Access Compliance Report

Public Rights-of-Way

Intersection ID: N/A	Main Street: SUMMERFIELD RIDGE LN	Cross Street: SUMMERGROVE CT	Location: NW
ADA ID: 1E7E101DB9A6	Ramp Type: PerpDiag	Initial Pass/Fail: Fail	Overall Compliance: No
		Severity Score: 8.75

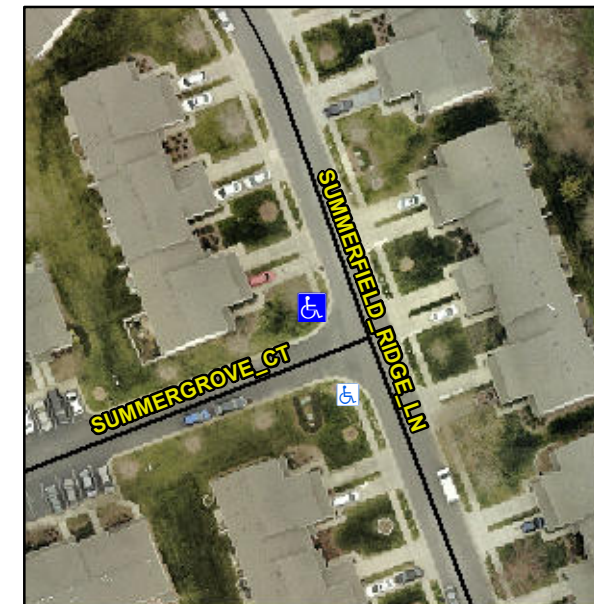
Not Found, R304.5.1

Compliance	Description	Data	Compliance	Description	Data
N/A	Ramp Length (in)	48.0	Yes	Ramp Slope (%)	7.2
No	Ramp Width (in)	39.0	Yes	Ramp XSlope (%)	1.9
N/A	Flare Type LT	N/A	N/A	Flare Type RT	N/A
N/A	Flare Slope LT (%)	N/A	N/A	Flare Slope RT (%)	N/A
N/A	Flare Traversable LT?	No	N/A	Flare Traversable RT?	No
N/A	Landing Length (in)	N/A	N/A	DWS Provided?	N/A
N/A	Landing Width (in)	N/A	N/A	DWS Contrast?	N/A
N/A	Landing Slope (%)	N/A	N/A	DWS Length (in)	N/A
N/A	Landing X Slope (%)	N/A	N/A	DWS Full Width?	N/A
N/A	Landing Curb? (Y/N)	N/A	N/A	DWS Offset (in)	N/A
N/A	Shared Landing?	N/A			
N/A	Gutter Ponding?	N/A	N/A	Gutter Slope (%)	N/A
N/A	Gutter Lip Ht (in)	N/A	N/A	Gutter X Slope (%)	N/A
N/A	Painted X Walk1?	No	N/A	Painted X Walk2?	Yes
	X Walk 1 Direction	To S		X Walk 2 Direction	To E
N/A	X Walk 1 Width (in)	N/A	N/A	X Walk 2 Width (in)	N/A
	X Walk 1 Slope (%)	2.5		X Walk 2 Slope (%)	1.8
	X Walk 1 X Slope (%)	2.1		X Walk 2 X Slope (%)	1.2

Remove & Replace Curb Ramp With Two New Directional Ramps or Equivalent.
